BMP NUMBER: **PC083**

Property Description: Middle Plantation Parcel C Championship Blackheath Course Holes 1-18

AS-BUILT SURVEY OF DAM#1

DAM #1 SECTIONS
FORD'S COLONY AT WILLIAMSBURG
OWNER / DEVELOPER: FORD'S COLONY AT WILLIAMSBURG, INC.
JAMES CITY COUNTY, VIRGINIA

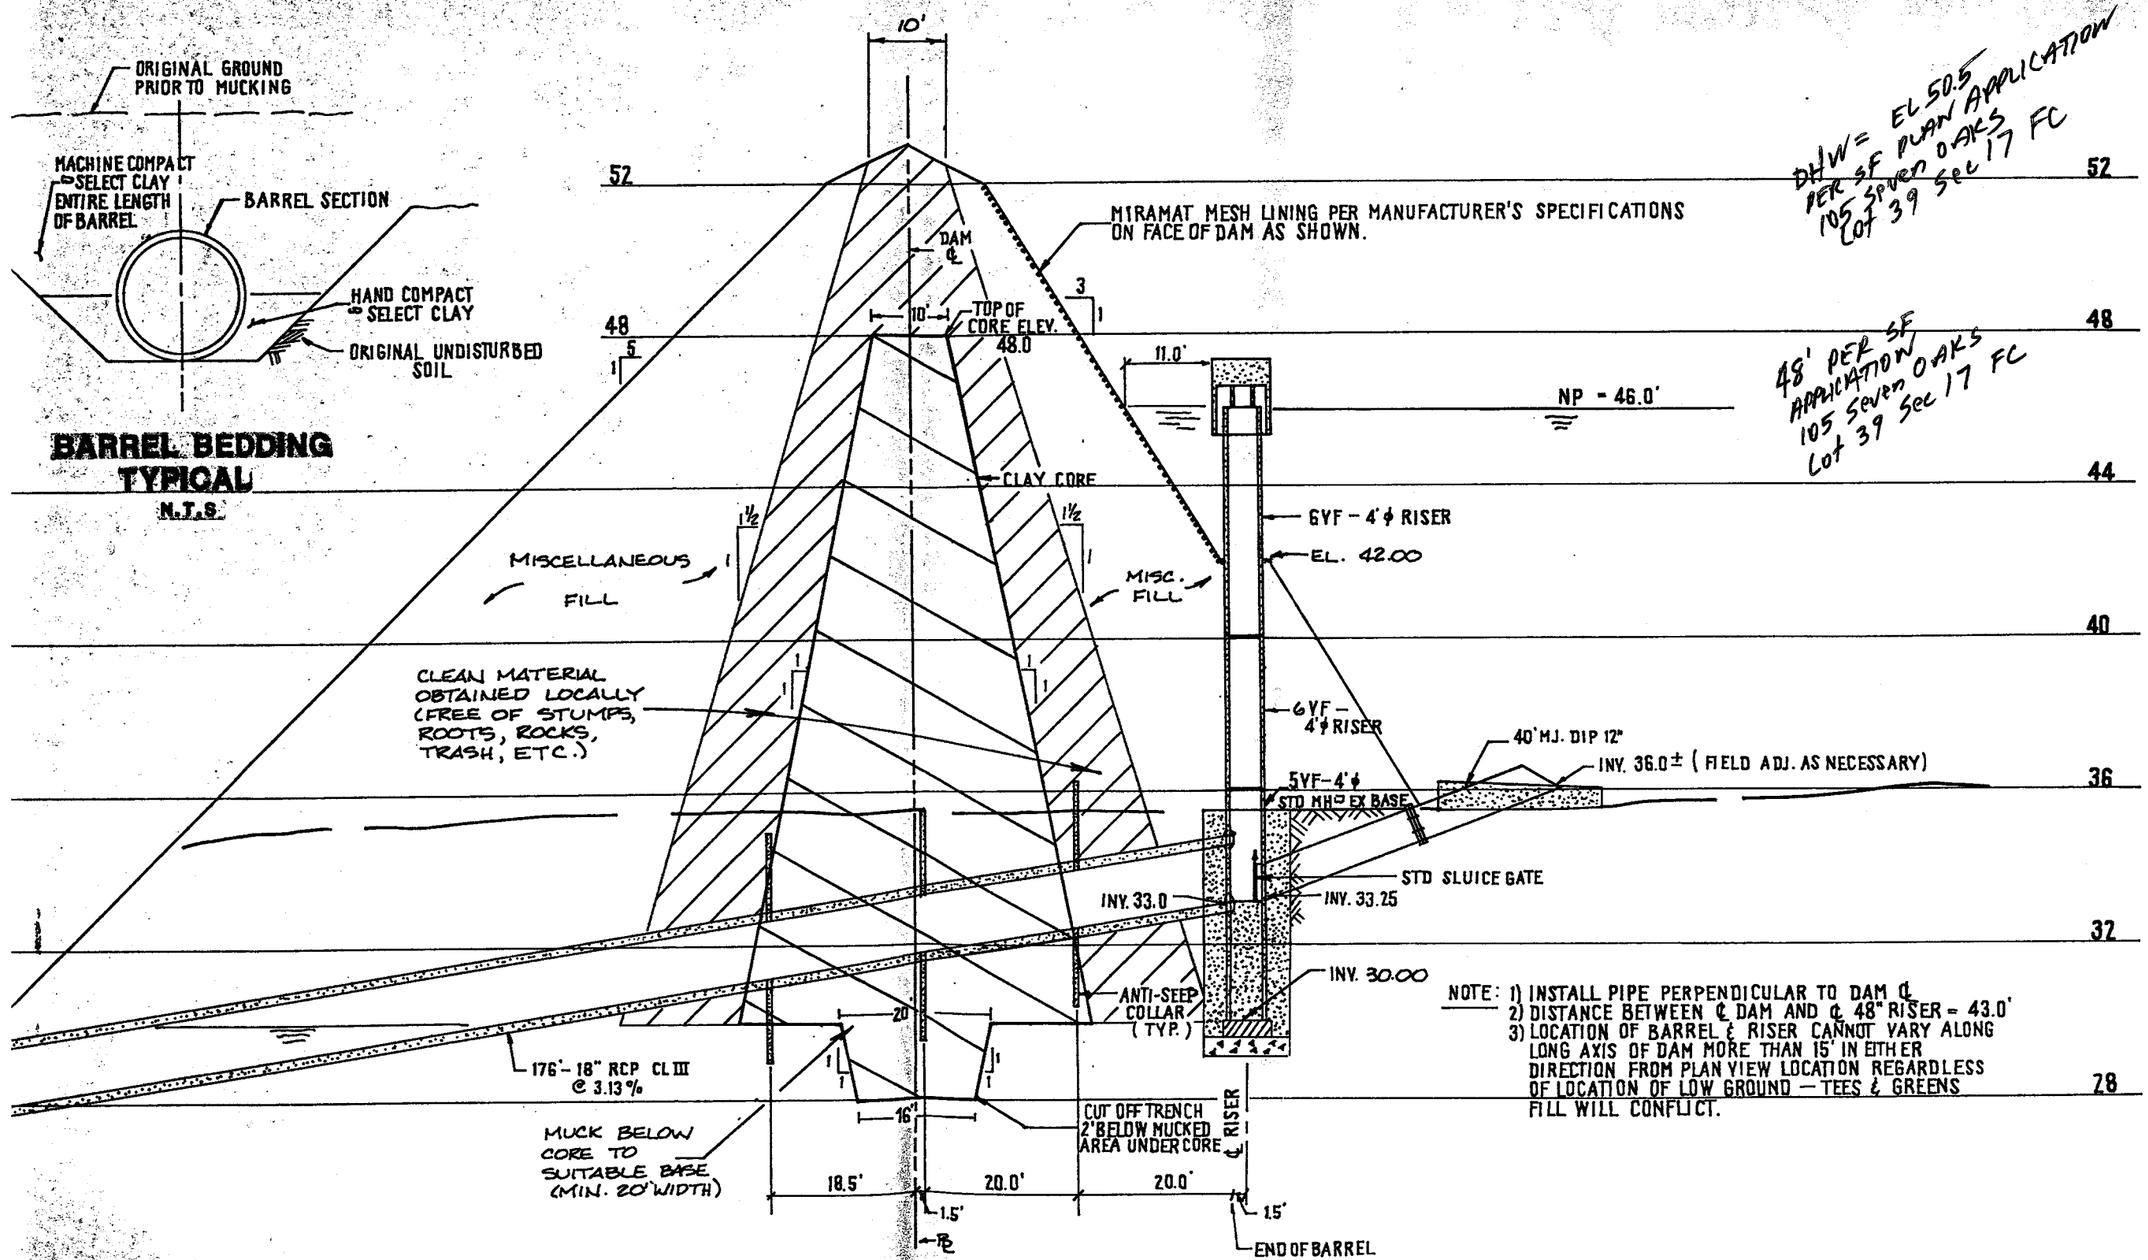
USE SF!

NOTE:
OWNER SHALL APPLY TO THE JAMES CITY COUNTY ENVIRONMENTAL DIVISION FOR A VARIANCE TO THE PROVISIONS OF THE 25 FOOT POND BUFFER REQUIREMENT.

Reconfigure the plan to conform with current setback/buffer requirements by avoiding disturbance of the pond buffer/setback area; or alternatively, if encroachment cannot be avoided due to the configuration of the lot, submit a written request for waiver to the Environmental Division The variance request needs to be from the owner or tenant, current or future, rather than the builder/ contractor. Efforts should be made to preserve existing trees and vegetation in the buffer during construction and to stabilize or landscape disturbed buffer area back to meadow or forest condition using native trees, shrubs or ground cover to the greatest extent possible.
